Application No.	Applicant(s)			
	10/549,394	TSUJI ET AL.			
Office Action Summary	Examiner	Art Unit			
	Gilbert Y. Lee	3673			
The MAILING DATE of this communication app Period for Reply	ears on the cover sheet with the c	orrespondence address			
A SHORTENED STATUTORY PERIOD FOR REPLY WHICHEVER IS LONGER, FROM THE MAILING DA - Extensions of time may be available under the provisions of 37 CFR 1.13 after SIX (6) MONTHS from the mailing date of this communication. - If NO period for reply is specified above, the maximum statutory period w - Failure to reply within the set or extended period for reply will, by statute, Any reply received by the Office later than three months after the mailing earned patent term adjustment. See 37 CFR 1.704(b).	ATE OF THIS COMMUNICATION 16(a). In no event, however, may a reply be tim ill apply and will expire SIX (6) MONTHS from cause the application to become ABANDONE	J. nely filed the mailing date of this communication. D (35 U.S.C. § 133).

Application/Control Number: 10/549,394 Page 2

DETAILED ACTION

GL 7/21/06 EXAMINER'S ATTACHMENT A U.S. Patent Sept. 30,1975 3,909,017

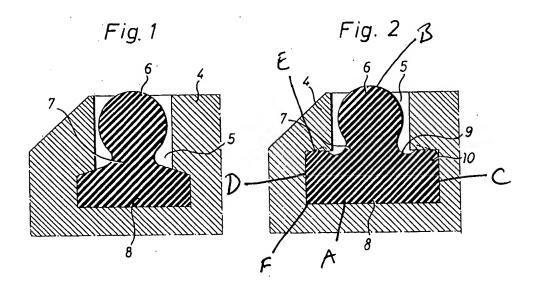
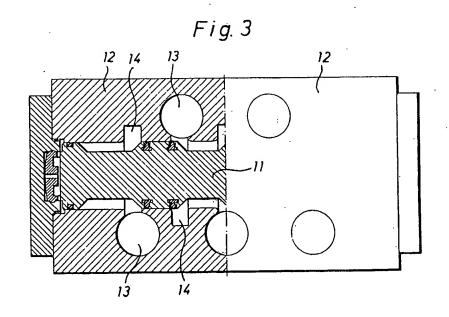
Regarding claim 6, the Engstrom reference discloses a sealing material (Col. 2, Line 8) for an ant groove (5), which is fitted to the ant groove made in a surface of either one of members in a joint place (11, 12) between these members and contacts with a surface of the other member (Fig. 3), thereby sealing both the members, with the sealing material comprising:

a sectional shape (Fig. 2) having a straight bottom edge (A) which is disposed on a bottom face of said ant groove (Fig. 2); an arched convex edge (B) which contacts with the surface of said other member facing said ant groove (Fig. 3); a first projecting edge (C) which connects with one end of said bottom edge and projects outside (Fig. 2); a concave inlet portion (9) which is located between said first projecting edge and said arched convex edge (Fig. 2); a second projecting edge (D) which connects with the other end of said straight bottom edge and is composed of straight lines that project outside (Fig. 2); a straight sloping edge (E) of which one end connects with the opposite end of said arched convex edge as to said first projecting edge and of which the other end connects with said second projecting edge (Fig. 2); and at least one corner portion (F) which is constituted in the range of from said straight bottom edge via said second projecting edge to said sloping edge (Fig. 2);

wherein: when the sealing material for the ant groove is fitted to said ant groove, said concave inlet portion is disposed on an opening edge of the ant groove (Fig. 2), and the sealing material for the ant groove gets pressed into the ant groove (Fig. 2). Note that the English equivalents to the patents described in the specification recite that the groove is an annular groove and has been treated as such for the examination of this application. Also note that the straight slope is connected to the arched convex edge through a concave portion (Fig. 2) and the sealing material is capable of gyrating.

FIG. 3

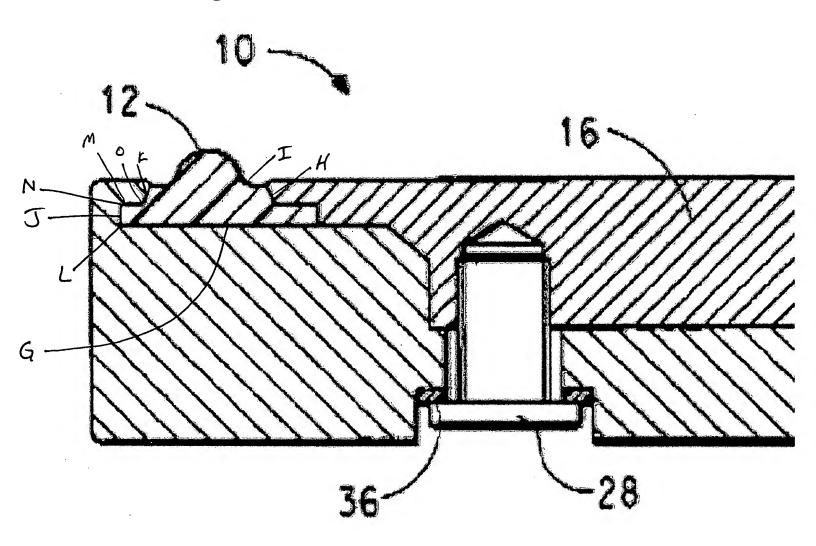
a sectional shape (Fig. 3) having a straight bottom edge (G) which is disposed on a bottom face of said ant groove (Fig. 3); an arched convex edge (12) which contacts with the surface of said other member facing said ant groove (Fig. 3); a first projecting edge (H) which connects with one end of said bottom edge and projects outside (Fig. 3); a concave inlet portion (I) which is located between said first projecting edge and said arched convex edge (Fig. 3); a second projecting edge (e.g. J and M) which connects with the other end of said straight bottom edge and is composed of straight lines that project outside (Fig. 3); a straight sloping edge (K) of which one end connects with the opposite end of said arched convex edge as to said first projecting edge and of which the other end connects with said second projecting edge (Fig. 3); and at least one corner portion (e.g. L) which is constituted in the range of from said straight bottom edge via said second projecting edge to said sloping edge (Fig. 3)

wherein: when the sealing material for the ant groove is fitted to said ant groove, said concave inlet portion is disposed on an opening edge of the ant groove (Fig. 3), and the sealing material for the ant groove gets pressed into the ant groove (Col. 2, lines 30-37). Note that the English equivalents to the patents described in the specification recite that the groove is an annular groove and has been treated as such

for the examination of this application. Also note that the straight slope is connected to the arched convex edge through a concave portion and horizontal edge (Fig. 3).

Regarding claim 8, the Kane et al. reference discloses said second projecting edge being formed by connecting a pair of straight edges (J and M) together in a triangular shape; and

said corner portion being constituted in the following three places: a place between said straight bottom edge and said second projecting edge (L); a crooked place of said second projecting edge (N); and a place between said second projecting edge and said sloping edge (O).
